**Historical Architectural Review Board**  
**COA Final Review Sheet**

**HDC-2023-00025**

**Address: 1033 ½ W. Court Street**

**Proposal: Demolish second-story rear porch; infill opening**

Rear of 1033 ½ W. Court Street, 2019.  
(Google StreetView)

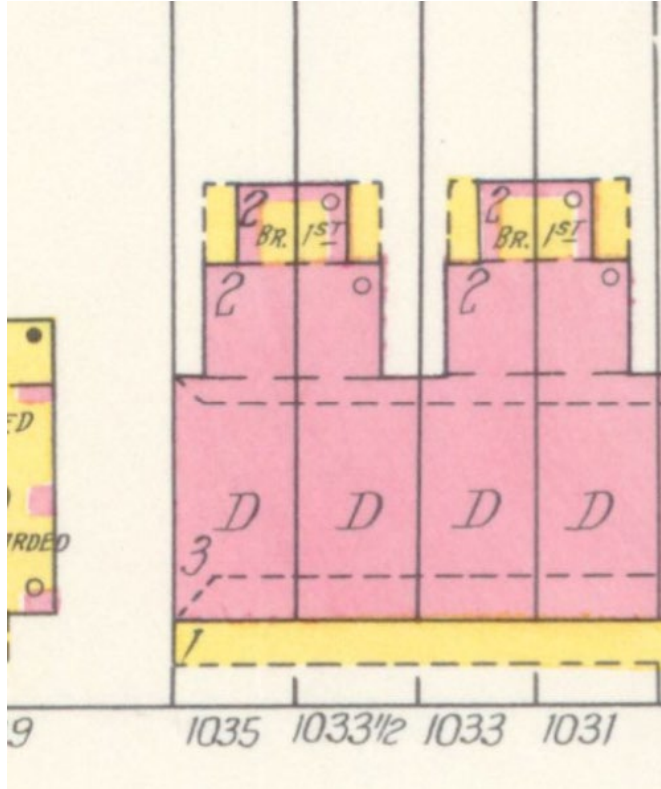
The design guidelines state that the guidelines apply to all types of front and rear porches, entry steps, rear yard balconies, or decks visible from the public right-of-way. The rear second-story porch of 1033 ½ W. Court Street is visible from Peach Street and should comply with the guidelines.

The property at 1033 ½ W. Court Street was constructed at the end of the nineteenth century as part of a row of six residential buildings that featured masonry rear ells with second-story frame porches. While there have been alterations to the rear porches, demolition would disrupt the form and rhythm of the buildings. Guideline 3.7.10 states that full removal of porches should be avoided, because it would negatively impact the building's historic character. Any features with severe deterioration should be replaced in kind or with an appropriate alternate material.

The application proposes to infill the door opening with painted T1-11 plywood. The existing rear door appears to be a standard six-panel door, though no clear photograph of the door has been provided. In general, staff recommends avoiding infilling openings and suggests that the existing door be permanently fixed, with the interior sealed, if access needs to be restricted.

Denial, pursuant to Chapter 3, Section 3.7 Porches & Steps.
